### Solicitation Addendum

Addendum No.: 1  
Solicitation No.: 21-TA003651DJ  
Project No.: 6041587  
Solicitation Title: Holmes Boulevard Force Main Replacement  
Addendum Date: April 7, 2021  
Procurement Contact: Dave Janney, Senior Procurement Agent

**IFBC 21-TA003651DJ is amended as set forth herein. Responses to questions posed by prospective bidders are provided below. This Addendum is hereby incorporated in and made a part of IFBC 21-TA003651DJ.**

**PLAN & PROFILE**  
**STA 77+00 - 82+00**

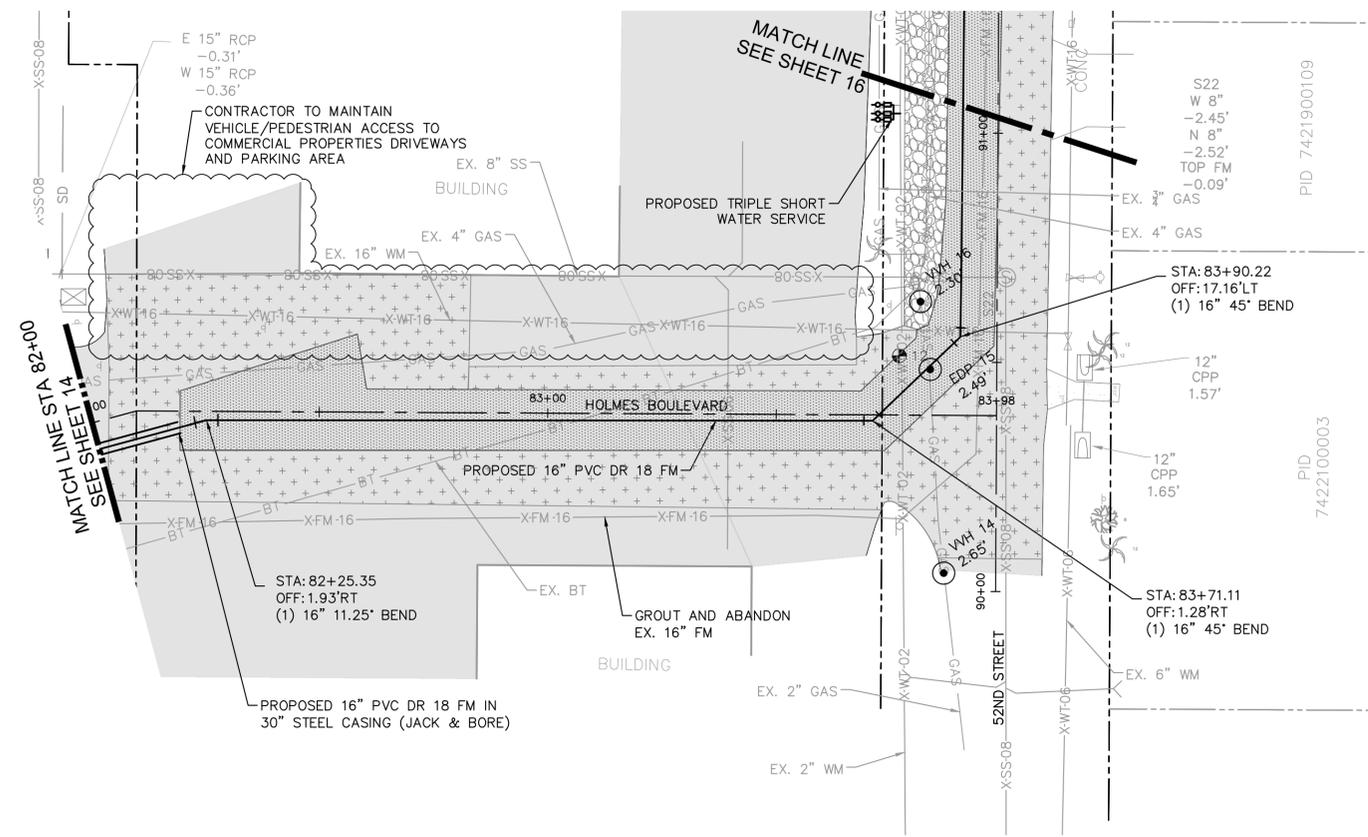
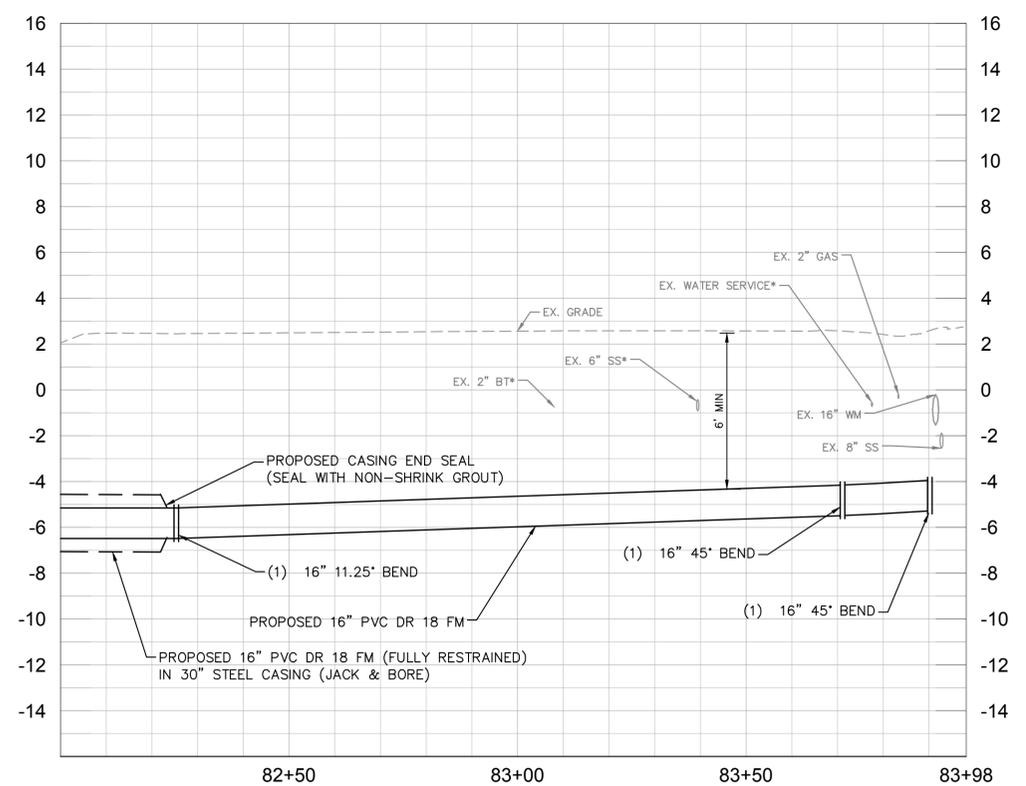
- Q55. Reference plan sheet 14, the Proposed Double Long Water Service at approximately Station 79+75, the plan sheet shows the line that this new double service is to replace as a 2-inch line currently providing service to the meter, please review and clarify.**

**PLAN & PROFILE**

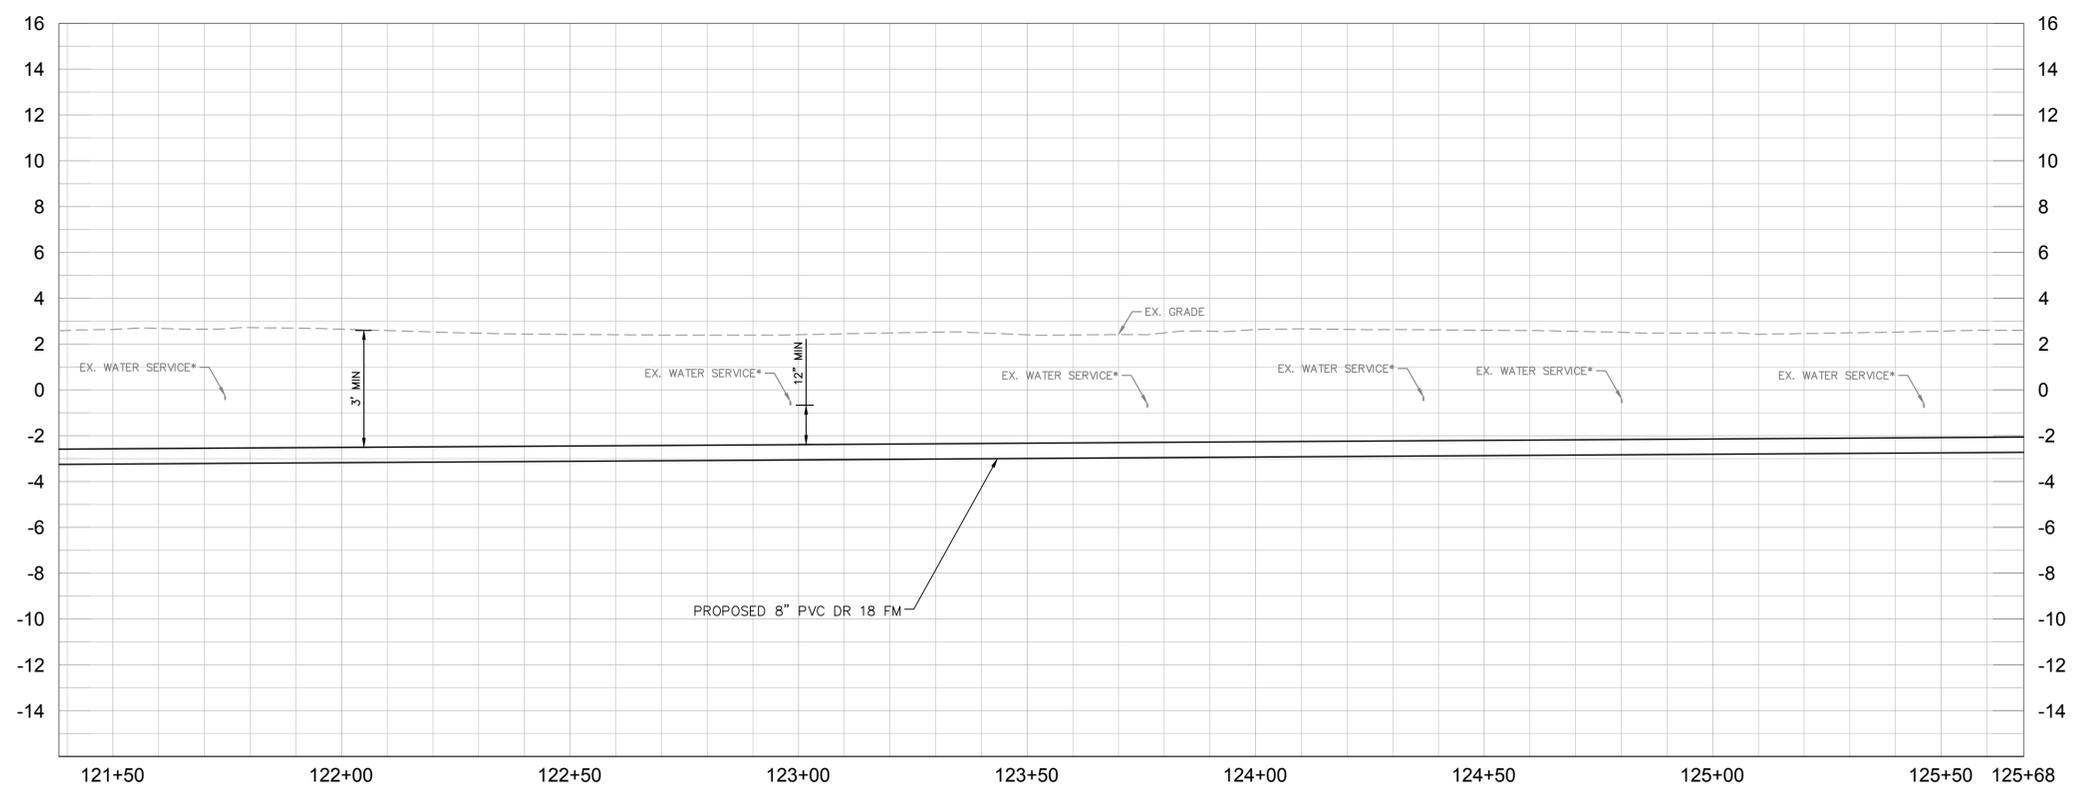
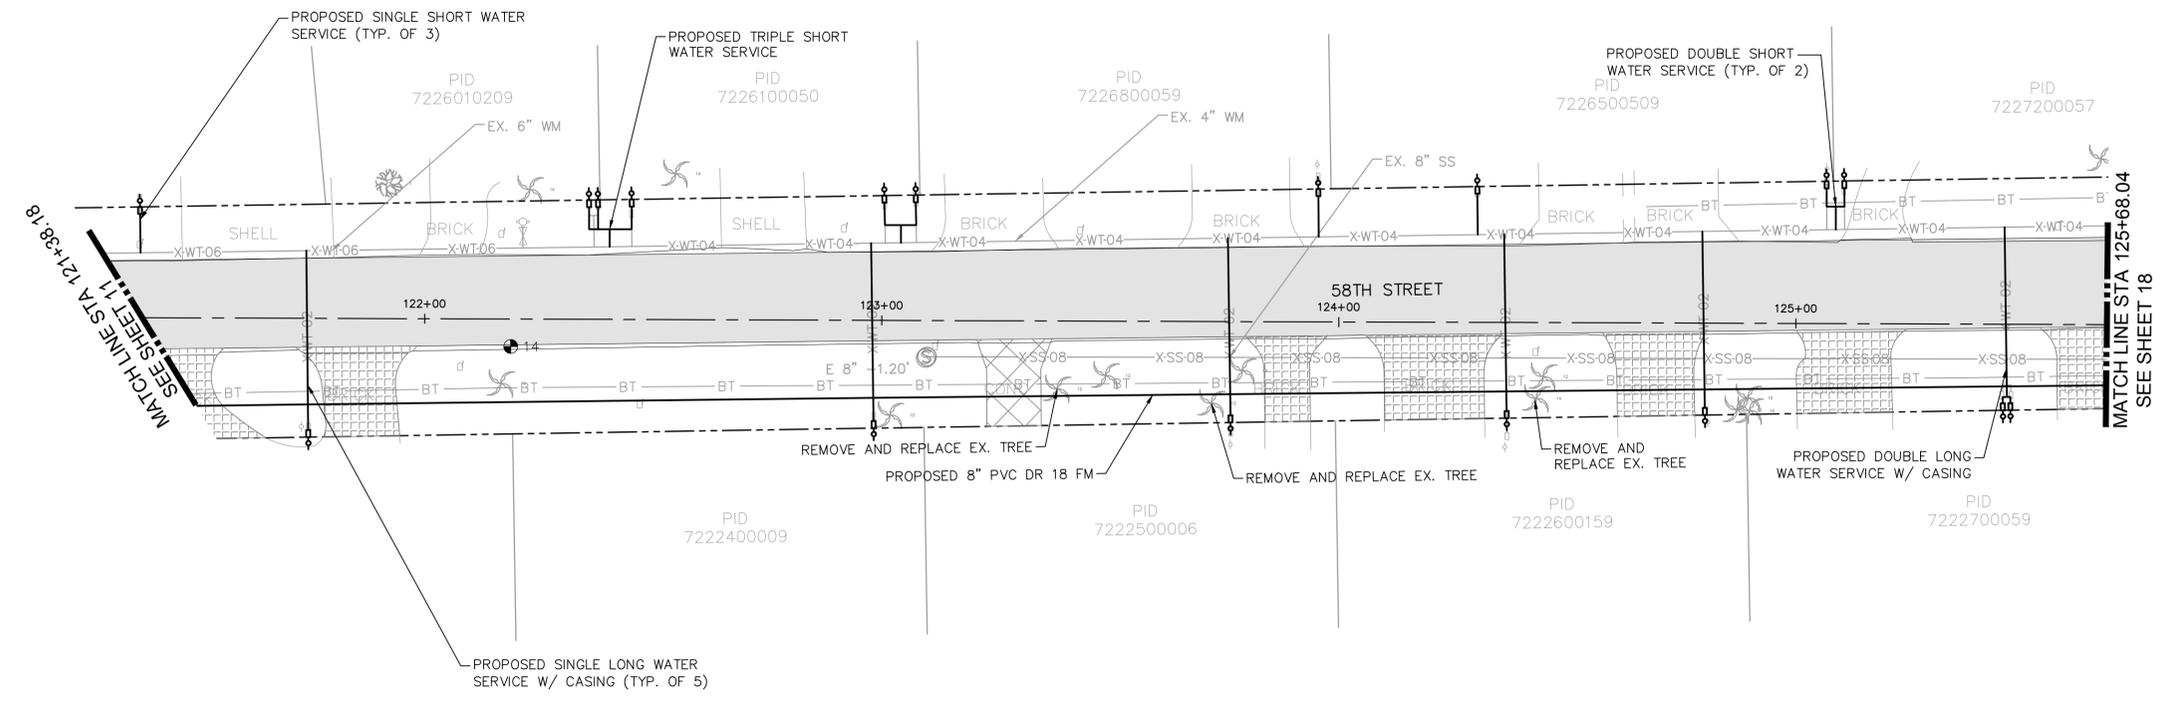
- Q27. Please provide pay item for the 16" Line Stop on sheet 16.**
- R27. Line stops are included under Bid Item No. 7 "Bypass Pumping".
- Q28. Please advise if the County will provide the water meter for the lift station. If not, please provide model and manufacturer.**

**Q50. Reference plan sheet 16, the existing 16-inch force main that currently discharges into the same manhole the new 16-inch force main has to be connected to, see plan sheet 16, how long can the existing force main be shut down?**
